# Request for FCC Class II Permissive Change

# Request for ISED Class II Permissive Change

FCC ID: SZGCFIZWH1  
IC: 7702A-CFIZWH1

This is to request for Class II permissive change for FCC ID: SZGCFIZWH1, originally granted on 2020/7/20, and ISED Class II Permissive Change for IC: 7702A-CFIZWH1, originally granted on 2020/7/21

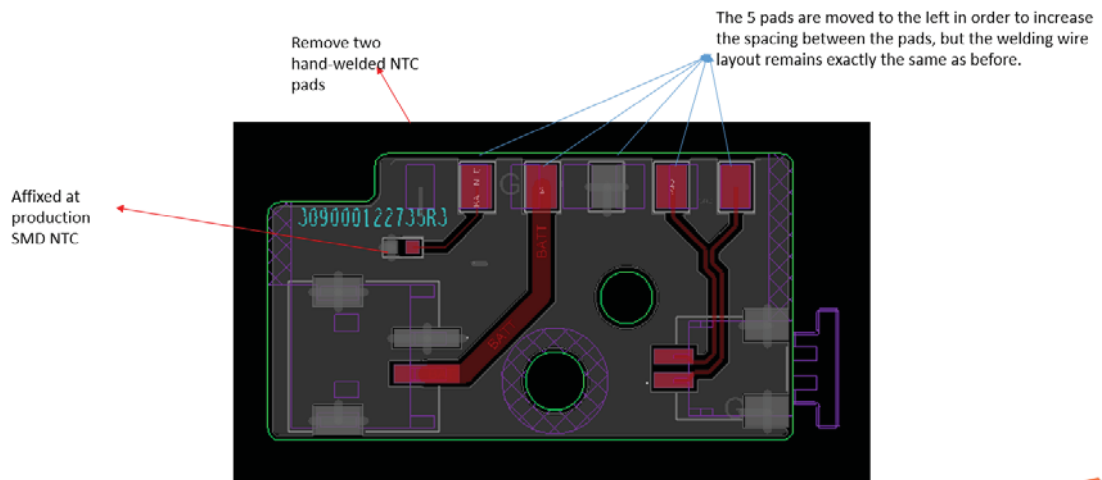
Remove the pads of the NTC parts of the DIP that were originally hand-welded, and shift the other 5 pads to the left in order. The spacing between the pads increases from 1.0mm to 1.5mm (to facilitate manual welding).
